## Bushfire Assessment Report

### Infill Development St John of God Hospital redevelopment, North Richmond

Version	Primary Author	Description	Date Completed
1.6	Lew Short	Final incorporating feedback from RFS	6 May 2021

### Figure 3 Wellness Centre (updated to be 10m from Boundary)

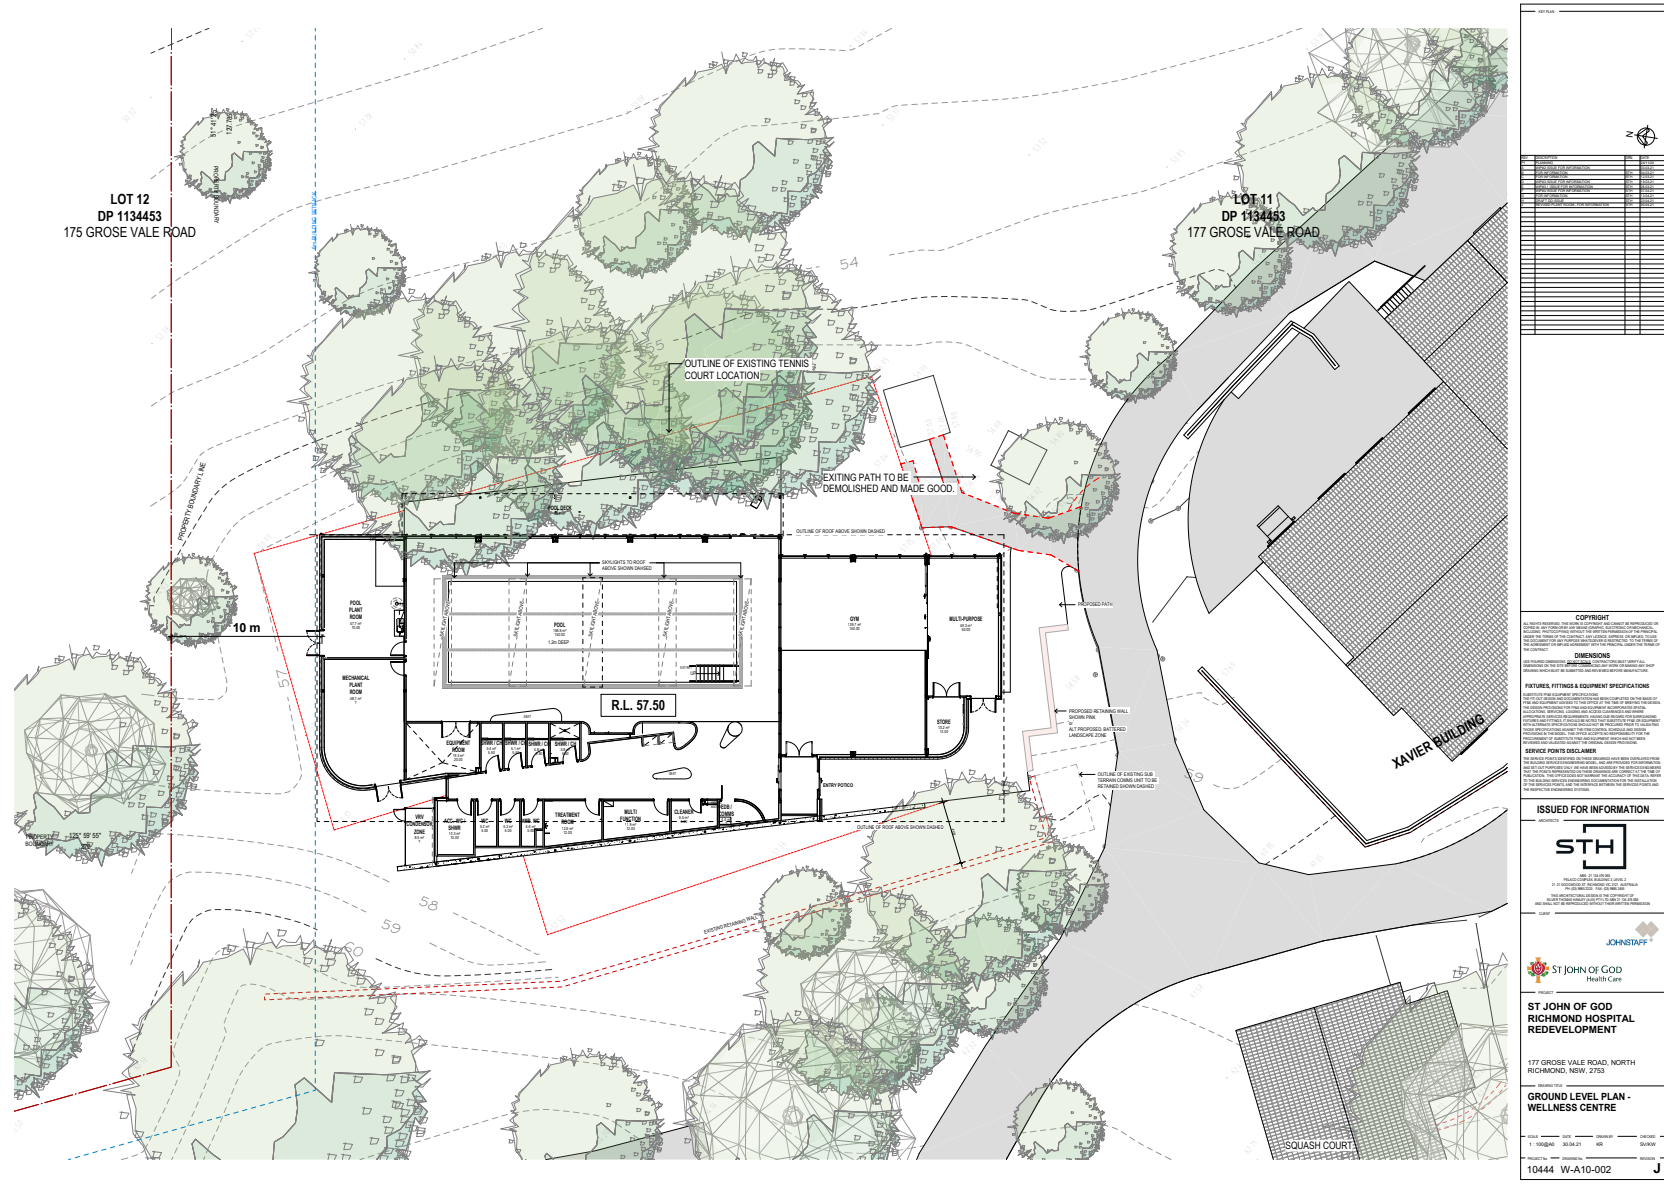
In response the comment from the RFS at the meeting of 22 April 2021, the Wellness Centre has been moved back from the boundary by 10m to get the building out of the Flame Zone. Due to site constraints this building cannot be moved to another location or further from the boundary.

Figure 6 Detailed Slope Map (updated showing relocated Wellness Centre)

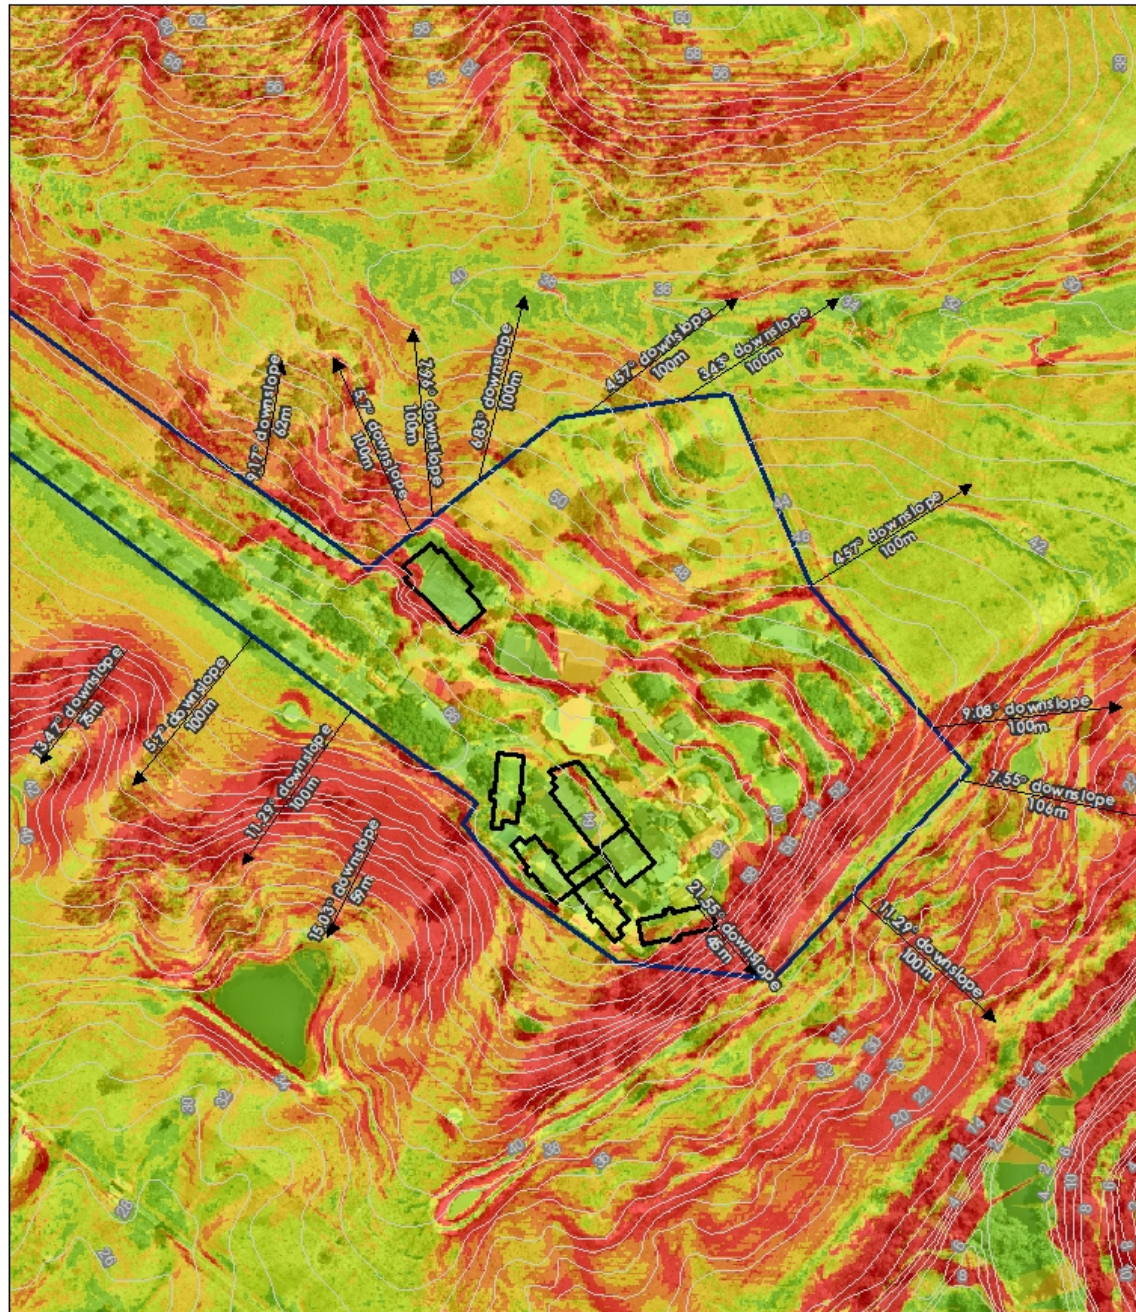
The slopes to the south east of the site are steep (21 degrees). However, this slope is short (< 25m) and is managed as an APZ.

Figure 7 BAL Map (updated showing Wellness Centre 10m from boundary)

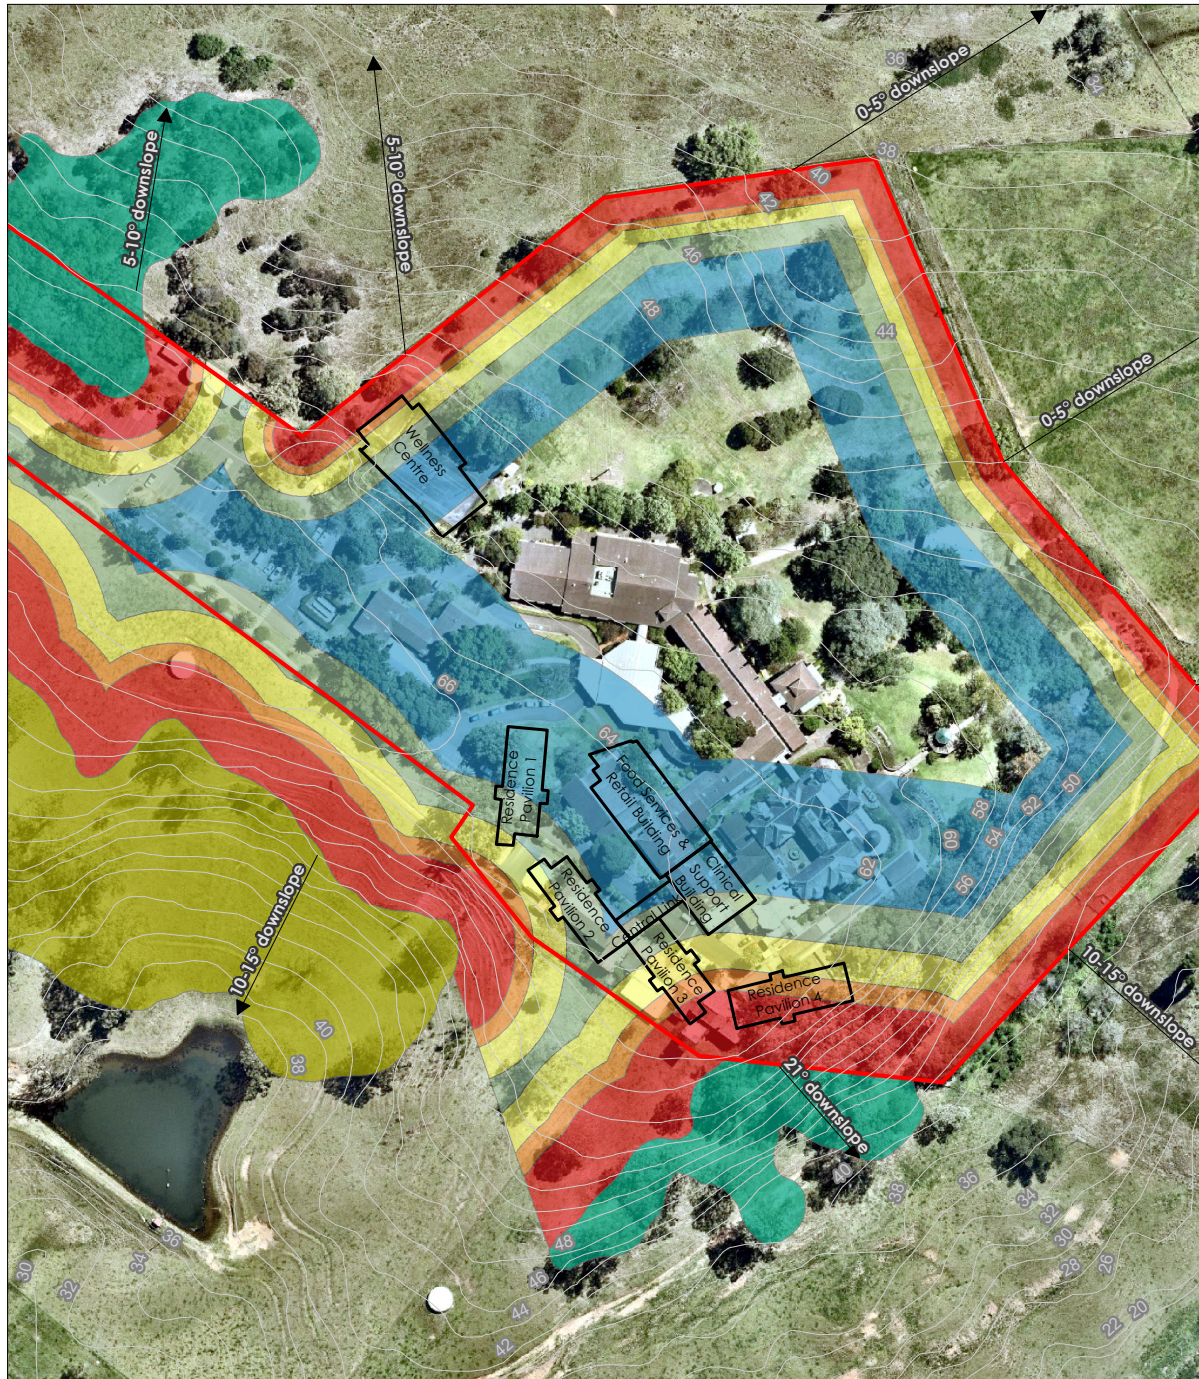
In response the comment from the RFS at the meeting of 22 April 2021, the Wellness Centre has been moved back from the boundary by 10m to get the building out of the Flame Zone. Due to site constraints this building cannot be moved to another location or further from the boundary. The

- The 1090K calculations show the Wellness Centre is at BAL 40 (with a radiant heat flux of 32.09kW/m<sup>2</sup> and flame length of 9.83m).
- The 1200K calculations show the Wellness Centre is at BAL FZ (with a radiant heat flux of 47.49kW/m<sup>2</sup> and flame length of 9.83m).

Due to the size of the building, it is proposed to use a performance-based approach to step the BAL levels down throughout the building (see Figure 7) such that the construction is:

- BAL 40 on the western side. Stepping down to BAL 40, BAL 29 and BAL 12.5 on the northern and southern elevations and BAL 12.5 on the eastern elevation as shown in Figure 7.
